El Camino Memorial Park
2nd Response to Development Service Department
Project No. GS 16B12
August 30, 2021

SUBJECT: El Camino Memorial Park Secret Canyon Expansion, 2nd Response to the City of San Diego Development Services Department # 670391-2 dated October 21, 2020, page 14, and # 0670391-4 dated June 11, 2021, located at 5600 Carroll Canyon Road San Diego, California 92121.

El Camino Memorial Park
Response to Development Service Department
Project No. GS 16B12
March 25, 2021

El Camino Memorial Park / Secret Canyon
Project No. GS 16B12-B
April 25, 2017

Exhibit: Infiltration Feasibility Condition Letter (C.1.1)

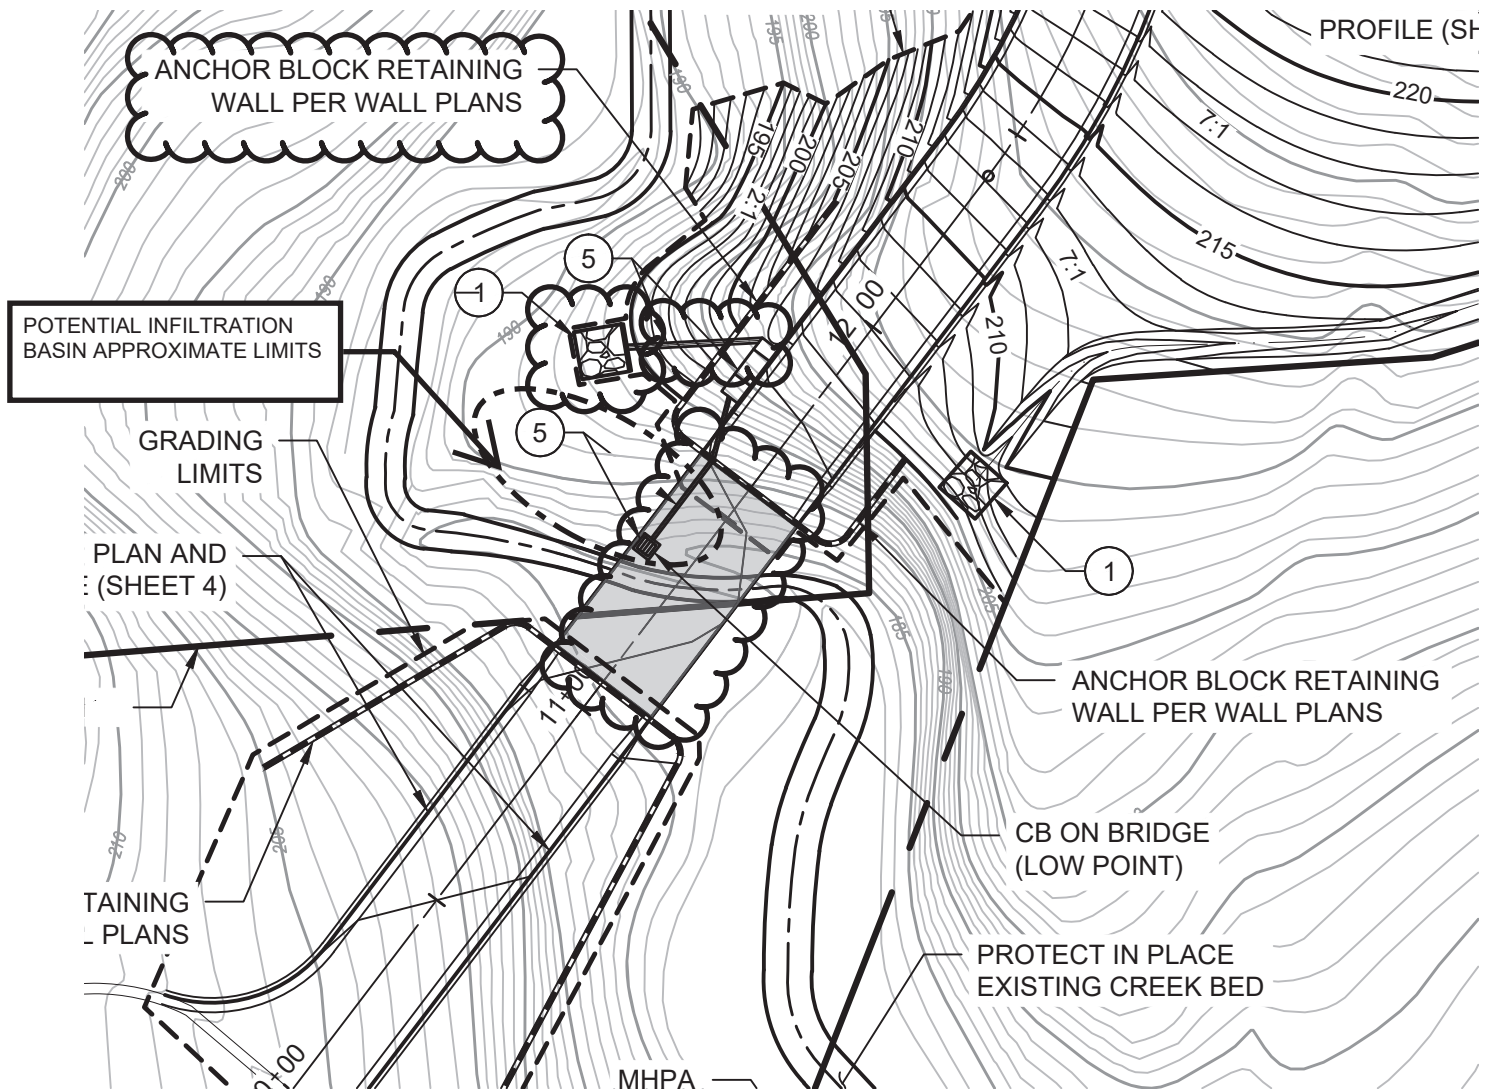
Issue # 6: Storm Water Requirements for the proposed conceptual development will be evaluated by LDR-Engineering review. Priority Development Projects may require an investigation of storm water infiltration feasibility in accordance with the current Storm Water Standards. Check with your LDR-Engineering reviewer for requirements. LDR-Engineering may determine that LDR-Geology review of a storm water infiltration evaluation is required.

This letter is to provide justification for a “No Infiltration Basis” finding for the referenced project. The 2018 SWQ Manual, Appendix C, Section C.1 and C.1.1 sets requirements for “No Infiltration” basis justification. Included are required minimum setbacks from structures of 10-feet for infiltration. The below project elements would not meet this requirement:

- 1) The proposed bridge structure
- 2) Drain inlet foundations and structures
- 3) Roadways

Clouded project elements do not meet required 10 foot setback for infiltration
